# MPS Baseline proposal

v240

Lennart Yseboodt, Philips

David Abramson, Texas Instruments

**Table 33–19—PD Maintain Power Signature**

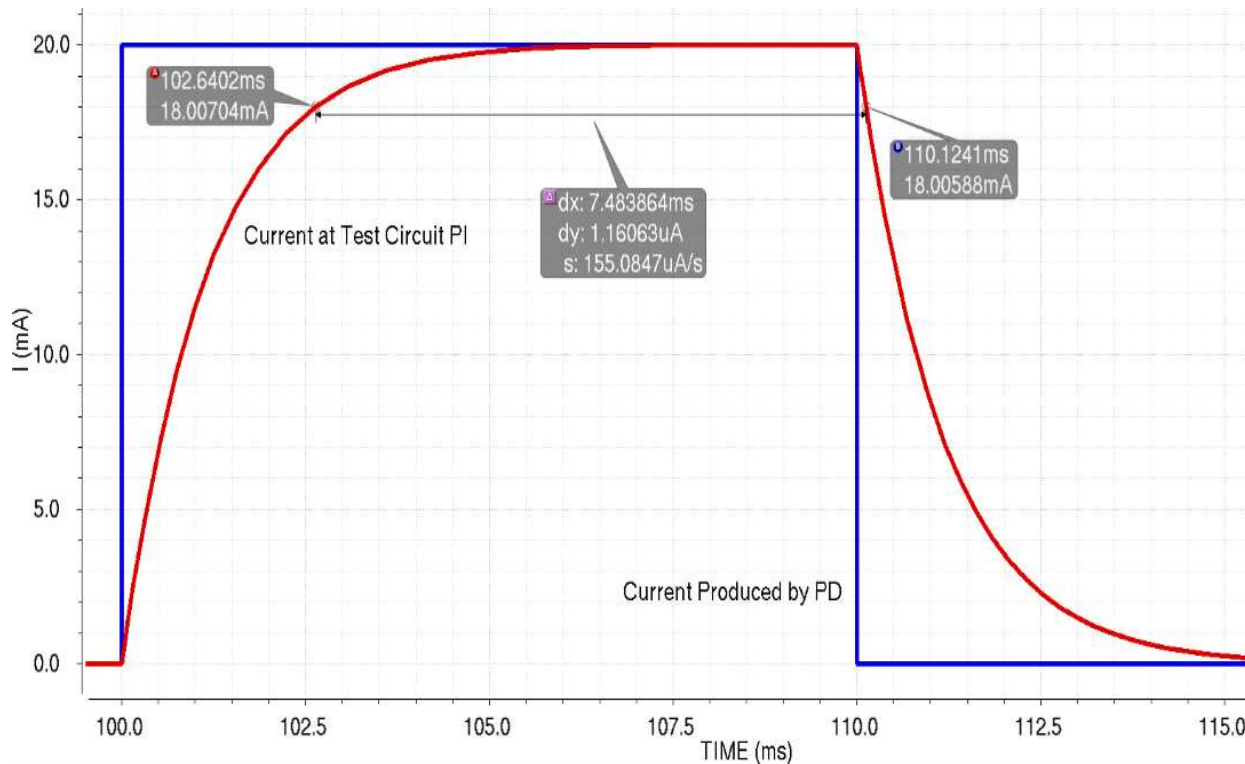
Item	Parameter	Symbol	Unit	Min	Max	Additional information
<del>1</del>	<del>Input current</del>	<del>I<sub>Port_MPS</sub></del>	<del>A</del>	<del>0.01</del>	<del>-</del>	<del>See 33.3.8</del>
1	Input resistance	R <sub>pd_d</sub>	kΩ		26.3	
2	Input capacitance	C <sub>pd_d</sub>	μF	0.05		See Table 33–12

In order to maintain power, the PD shall provide a valid Maintain Power Signature (MPS) at the PI. The MPS for Type 1 and Type 2 PDs shall be current draw equal to or above **10 mA** for a minimum duration of **75 ms measured at the PD PI** followed by an optional MPS dropout for no longer than 250ms . The MPS for Type 3 PDs shall be:

- a) Current draw equal to or above **10 mA** for a minimum duration of **75 ms measured at the PD PI** followed by an optional MPS dropout for no longer than 250ms **when connected to a Type 1 or 2 PSE, and**
- b) Current draw equal to or above **TBD mA** for a minimum duration of **7 ms measured at the Test Circuit PI in Figure 33-##** followed by an optional MPS dropout for no longer than **318 ms when connected to a Type 3 PSE.**

In addition, the MPS for all PDs shall have input impedance with resistive and capacitive components as defined in Table 33–19.
